# UNITED STATES PATENT AND TRADEMARK OFFICE

10/535,266

## FINAL REJECTION

forms a groove *between* each of the projections. To illustrate this groove, the examiner has attached a marked up version of figure 7 from Kim below.

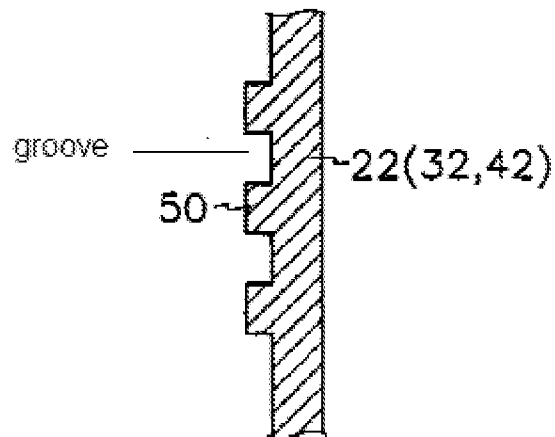
4. Applicant's arguments filed October 31, 2007 have been fully considered but they are not persuasive. Applicant argues that the groove 14B of the instantly claimed invention prevents adhesive from leaking to the periphery of the chassis member. The applicant should note that while the specification describes the function of the groove in such a manner, the claim does not recite that the groove prevents adhesive from leaking to the periphery. Rather the claim only requires that the groove be formed at the periphery of the holding plate, and that adhesive flow into the groove. It is noted that limitations recited in the specification are not read into the claims.

The applicant further states that the prior art of record does not disclose a groove. The applicant is respectfully notified that formation of a plurality of projections

Thus, the examiner asserts that Kim does disclose a groove. The examiner further asserts that Kaneko in view of Chung and Kim renders the limitation "wherein a groove in which a portion of the adhesive flows is formed at a periphery of the holding plate" obvious.
